ORIGINATION FORM

Proposed Revisions to a Standard Plans Index (Please provide all information — Incomplete forms will be returned)

Index Number: 425-060

Index Title: Back of Sidewalk Drainage

===== TYPE C (MODIFIED) INLET =====
 (Pipe Connection Not Shown)

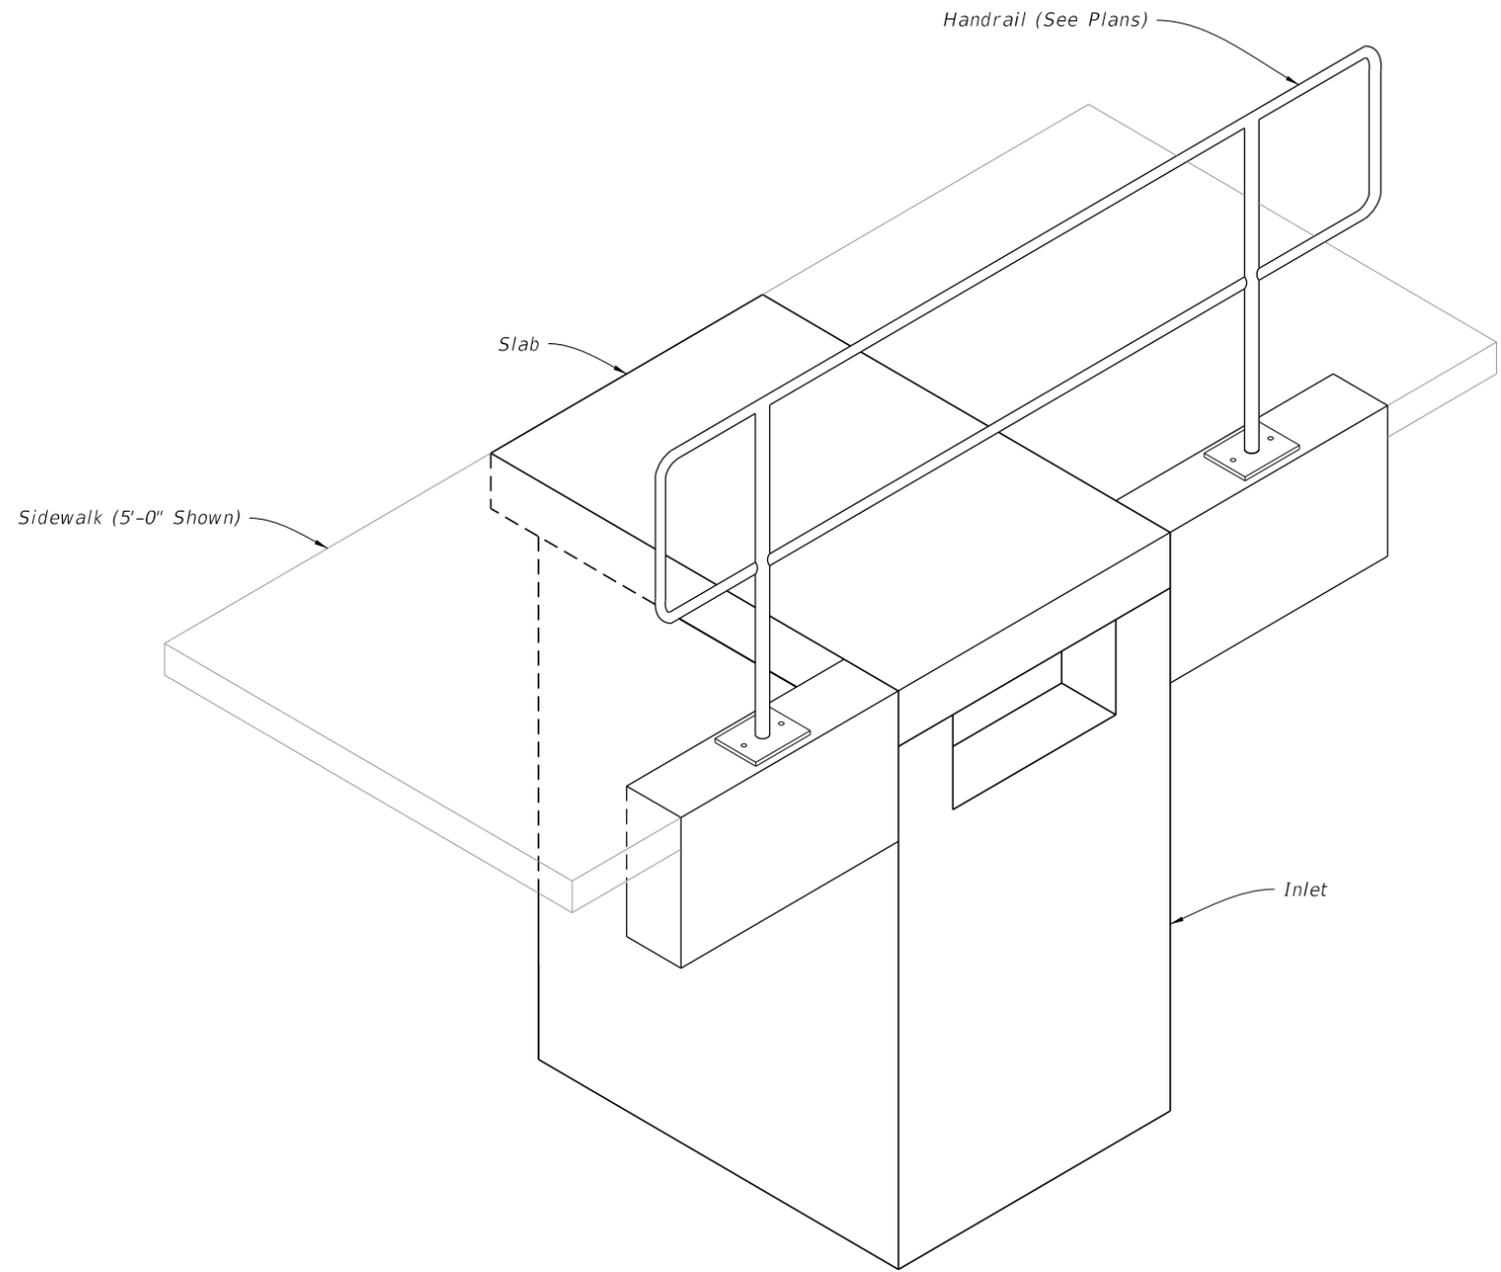
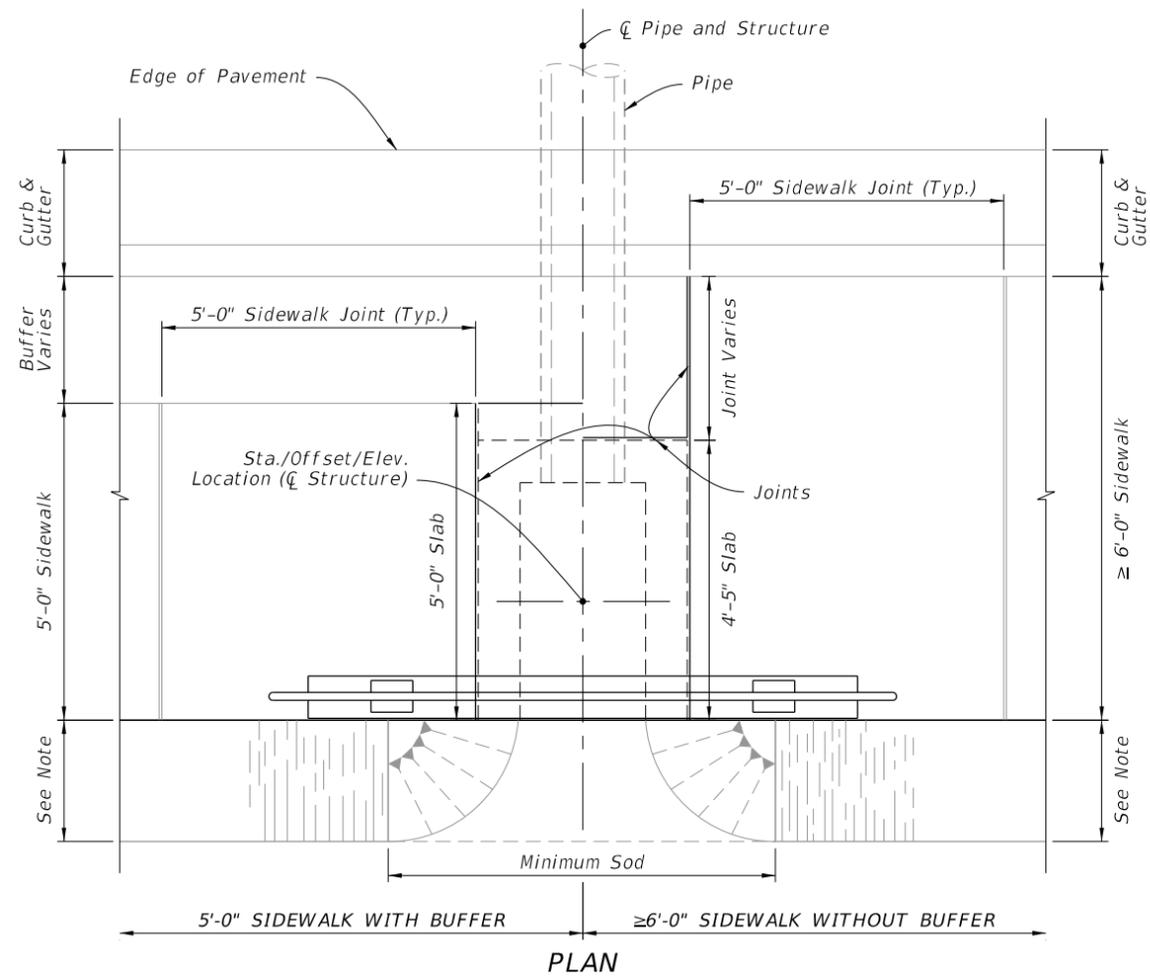
Sheet 2: Type C Inlet (Modified)

SPECIAL CONCRETE ENDWALL

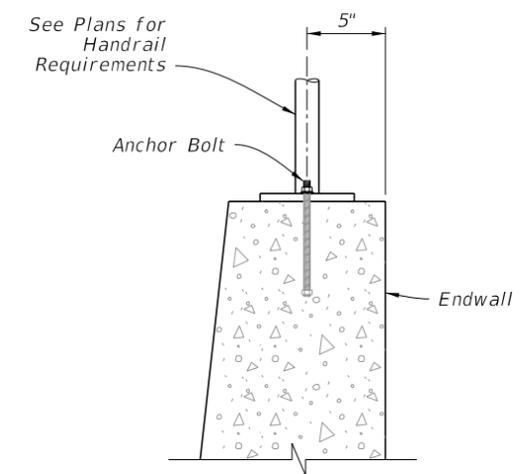
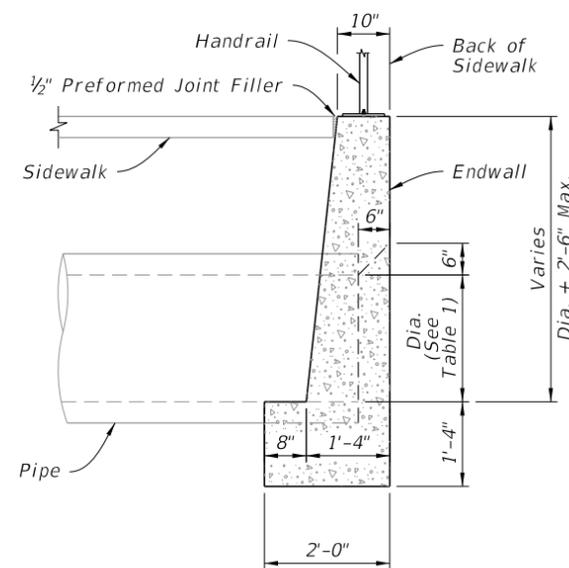
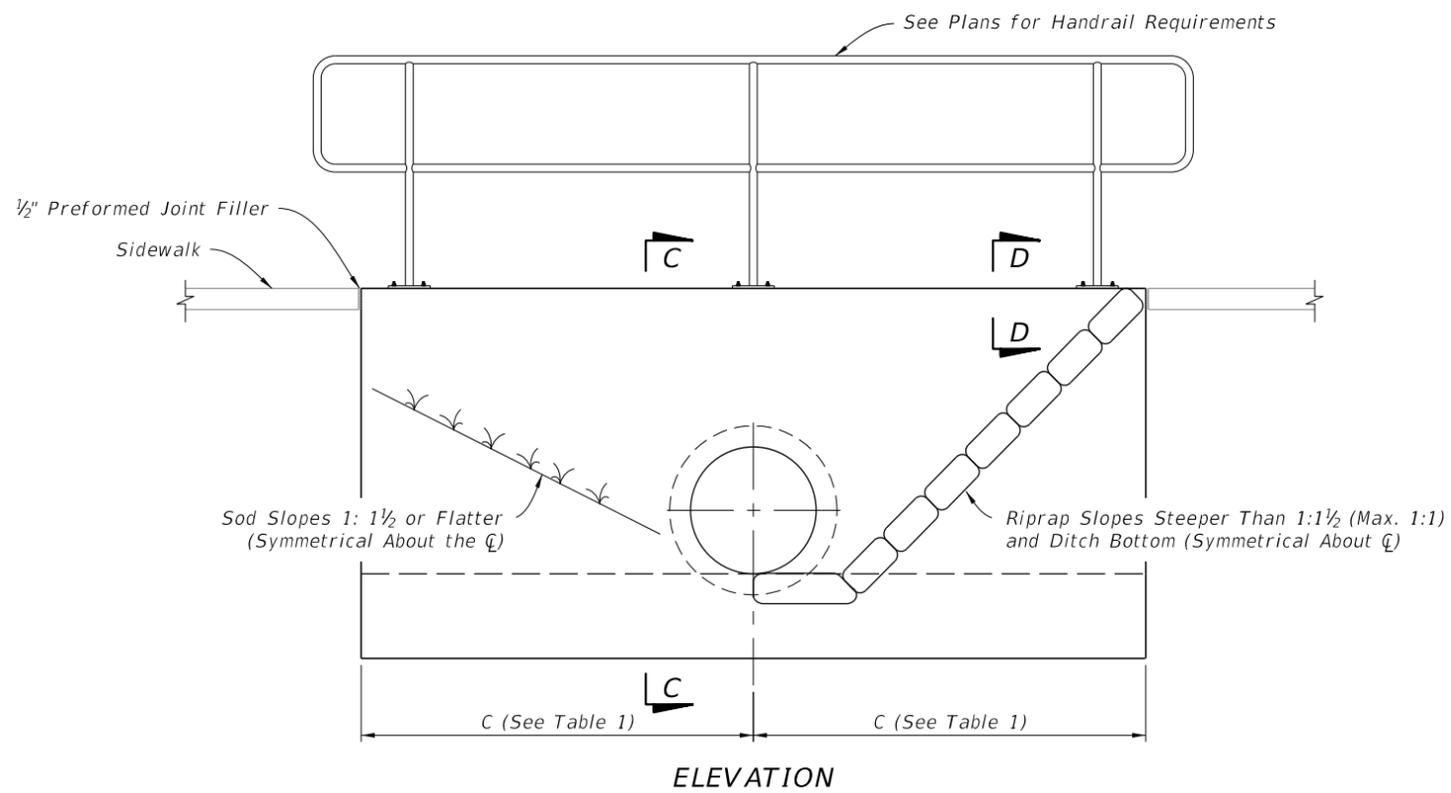
Sheet 3: Special Concrete Endwall

SHALLOW DITCHES AND YARD DRAINS

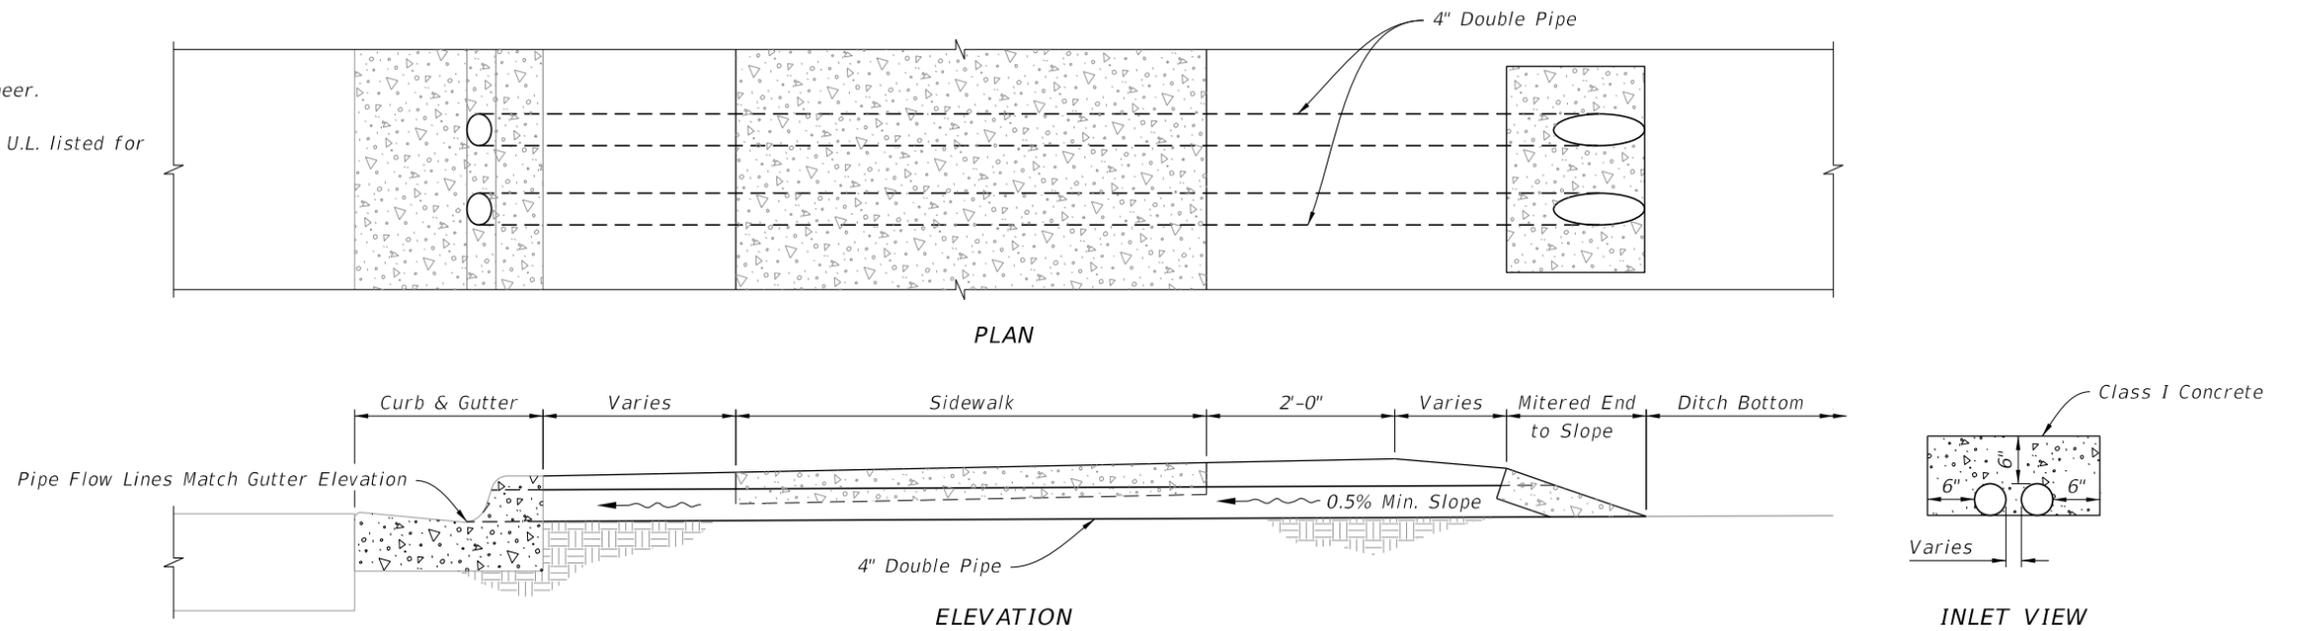
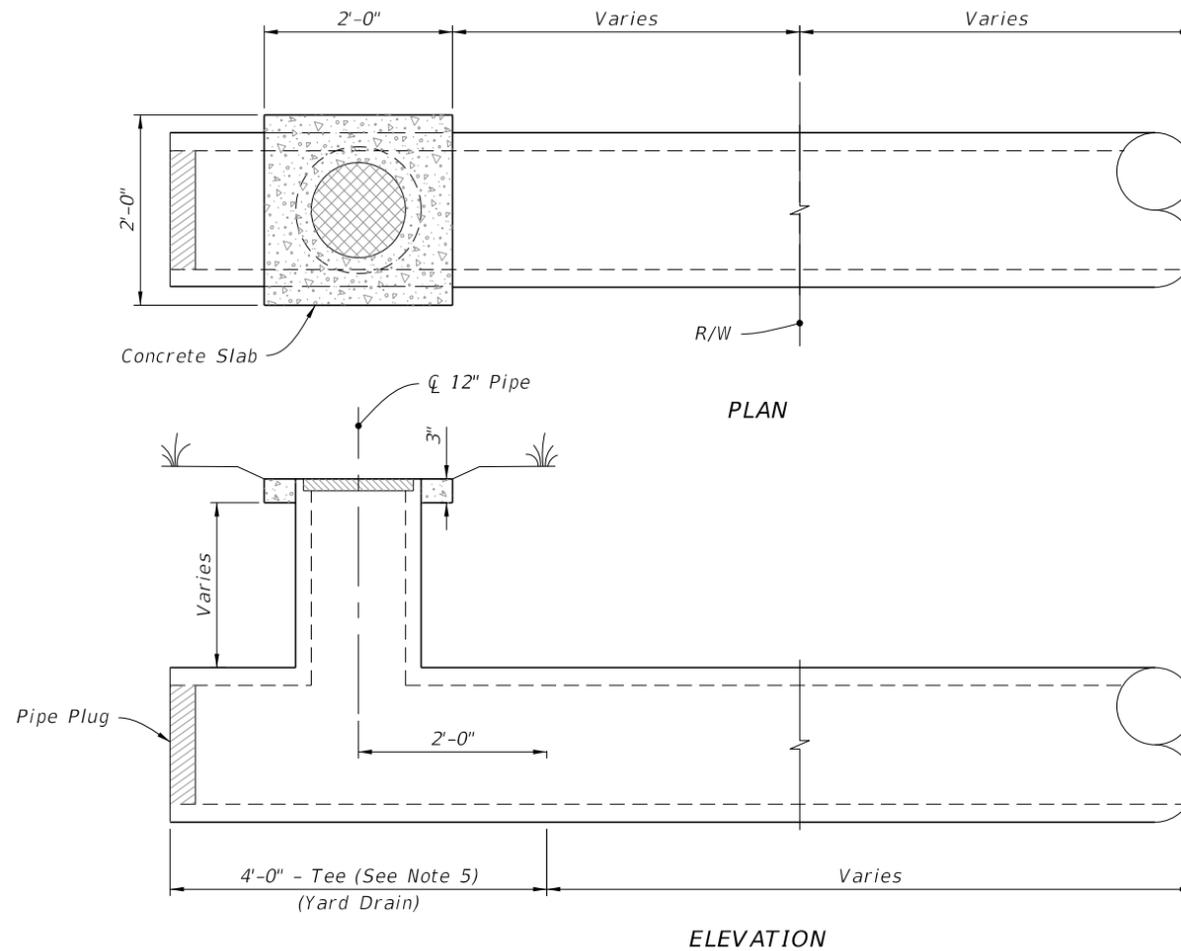
Sheet 4: Shallow ditches and Yard Drains
